DOCKET NOS.: 50-438, 439, 452, 453 AND 460

FACILITIES : BELLEFONTE NUCLEAR PLANT, UNITS 1 AND 2; GREENWOOD ENERGY CENTER, UNITS 2 & 3; WASHINGTON NUCLEAR PROJECT-1

SUMMARY OF GENERIC MEETING WITH BABCOCK & WILCOX (B&W) ON CONTAINMENT PEAK PRESSURE ANALYSIS

REACTOR BUILDING PRESSURE HISTORY FOR MASS X ENERGY RELEASE
DEVELOPED BY CRAFT AND REFLOOD

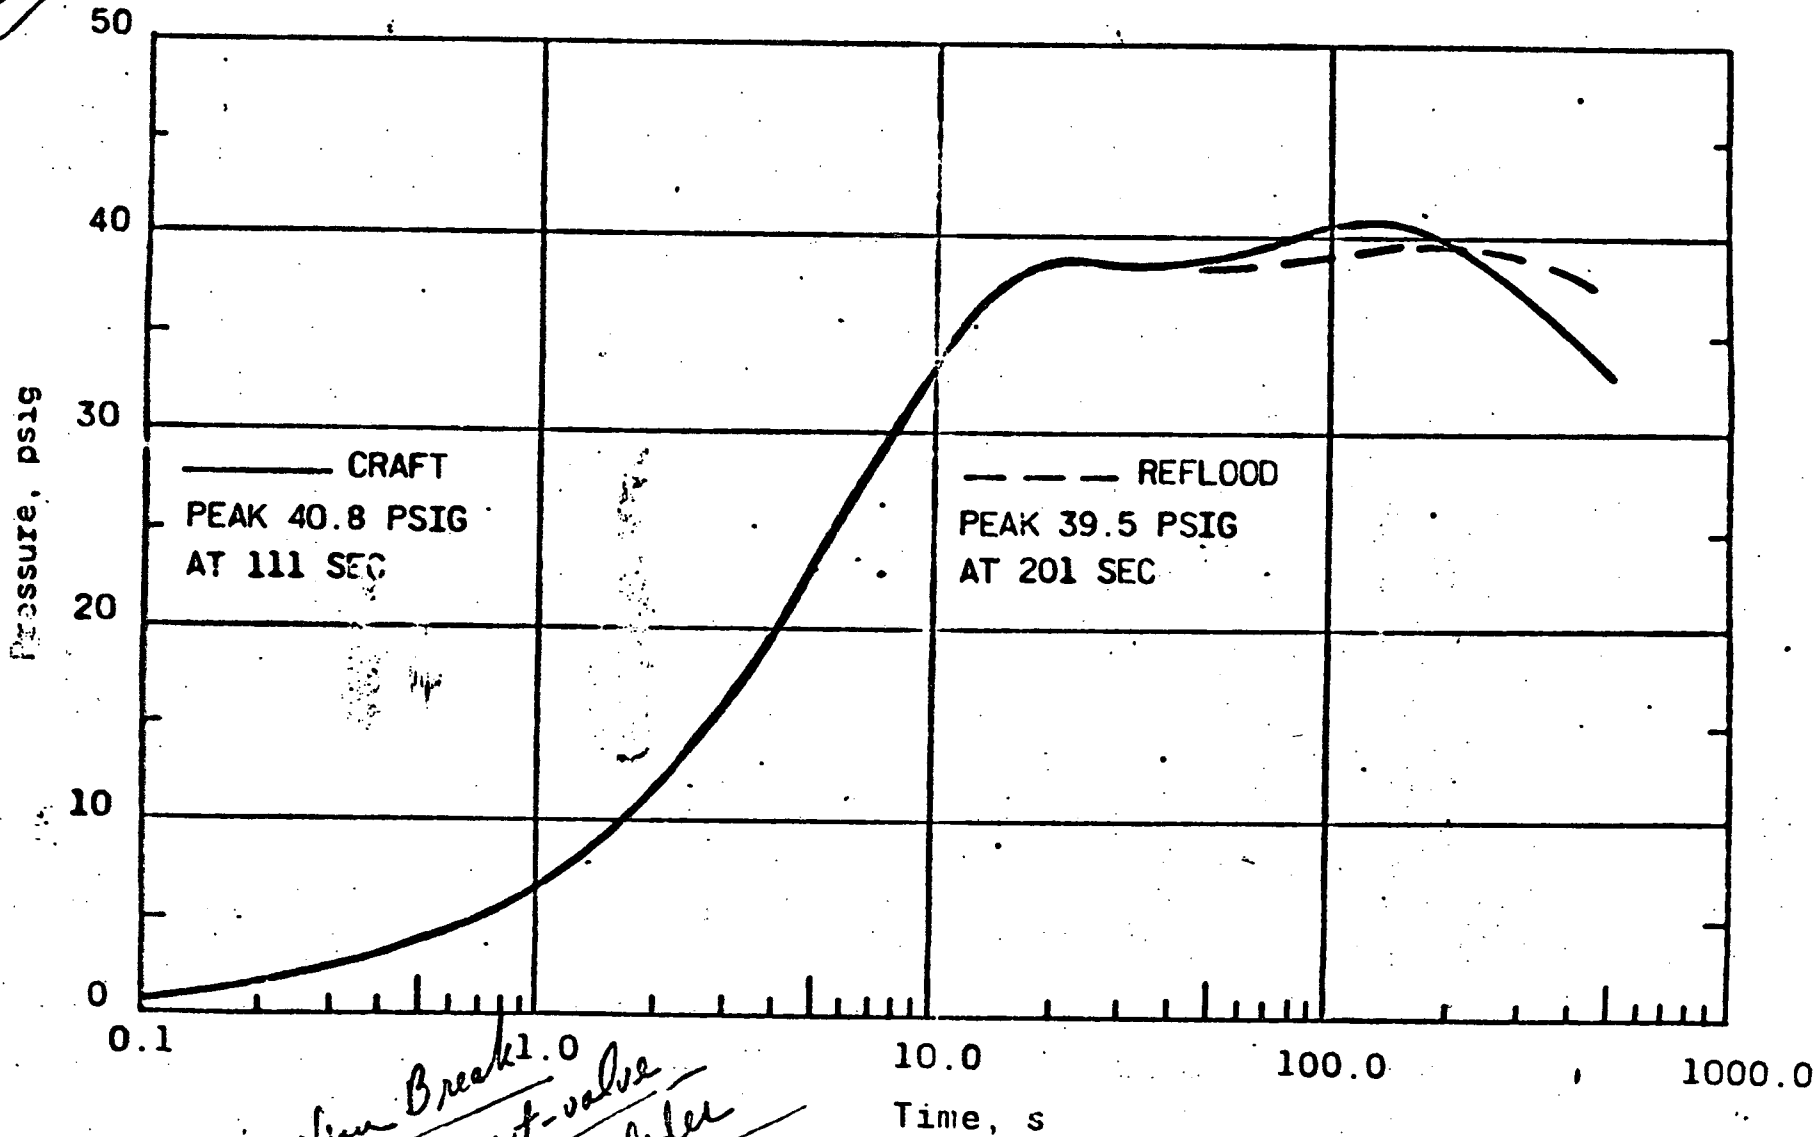
The REFLOOD code is used in B&W's ECCS analysis to compute the inlet flow rate to the core during the reflooding period. This code appears to be similar to the staff's FLOOD code that is used to predict mass and energy release to the containment during the reflooding period. B&W presented comparisons showing that CRAFT code predicted a greater mass and energy release than the REFLOOD code. The staff noted that the input assumptions used in the REFLOOD code were more typical of those for ECCS analysis and may not be conservative for containment analysis.

COMPARISON OF QUENCHING AND NON-QUENCHING IN CRAFT

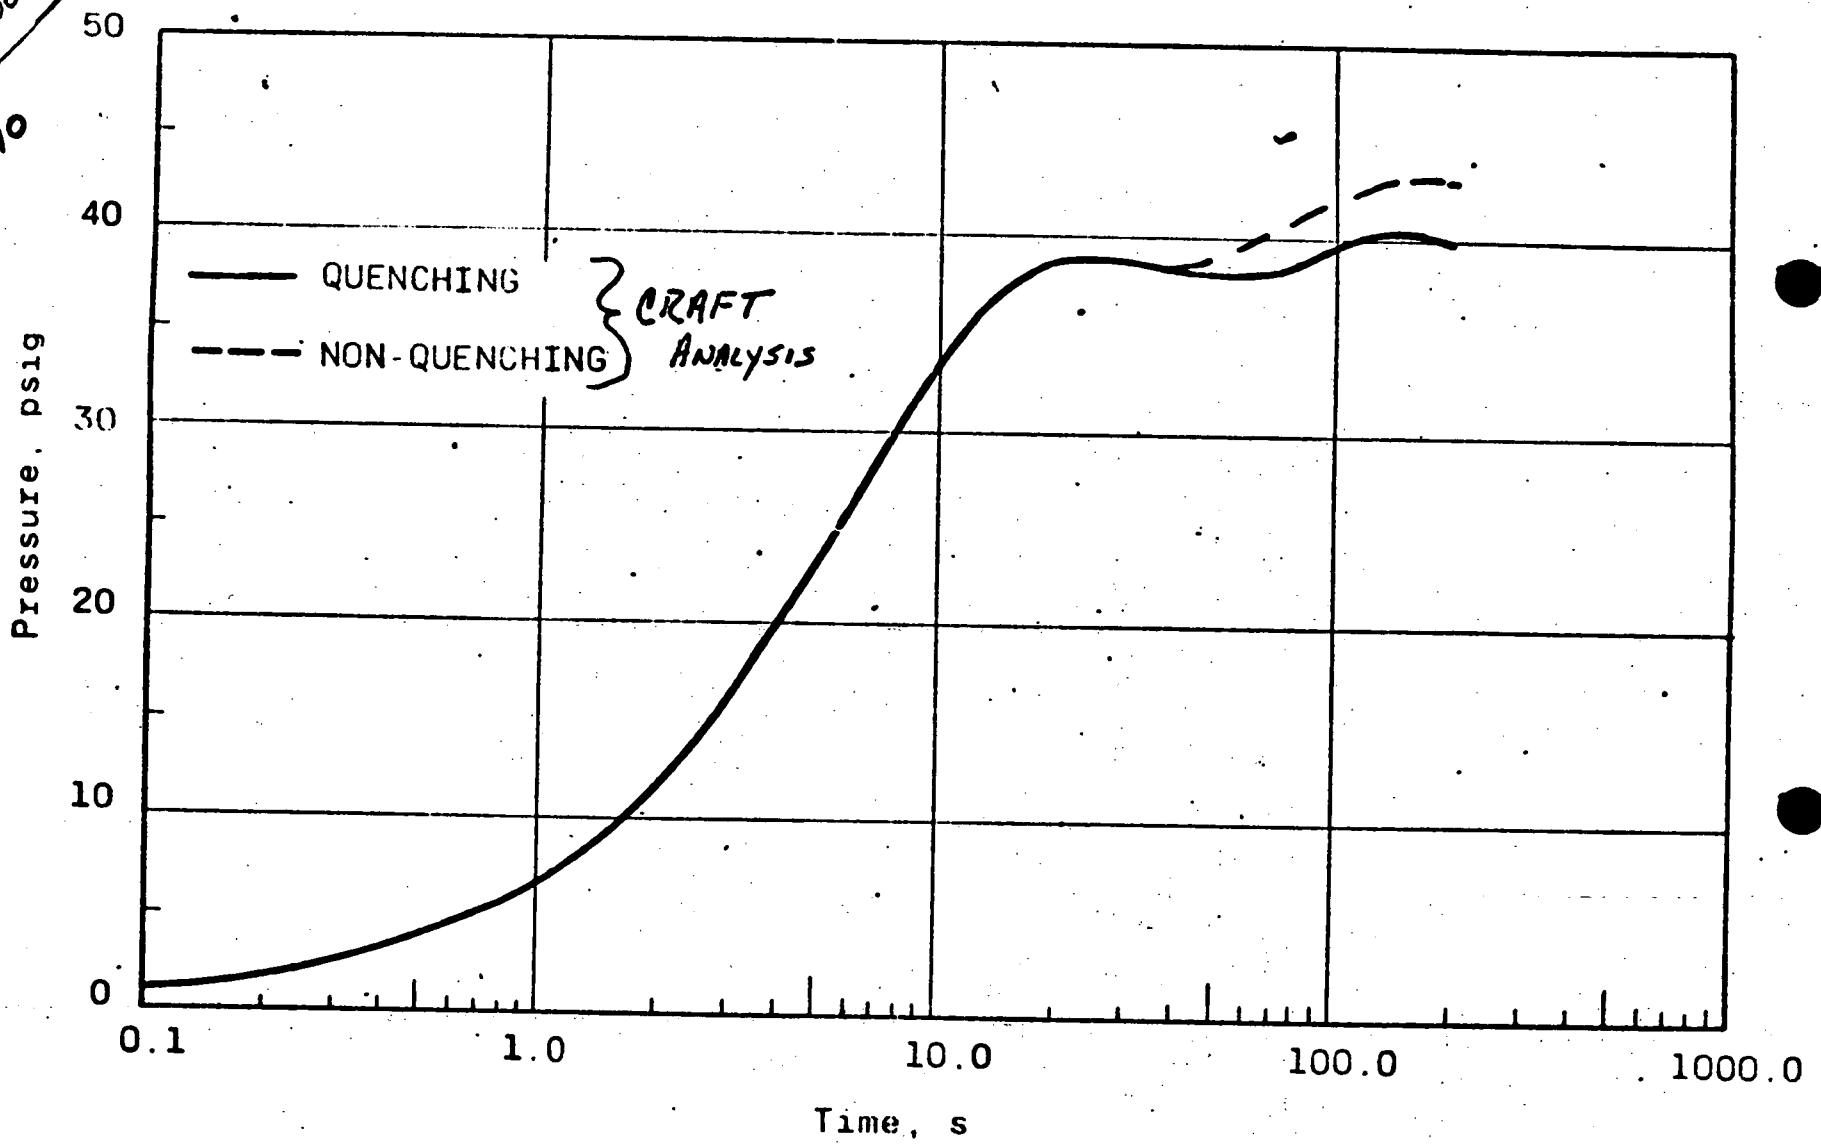
The staff had stated that the assumption of complete steam-water mixing used by B&W reduced the steam flow into the containment and did not appear to be conservative. This assumption reduces the peak containment pressure by about 2 psi and reduces the containment decompression time. B&W presented data from the Combustion Engineering steam-water mixing
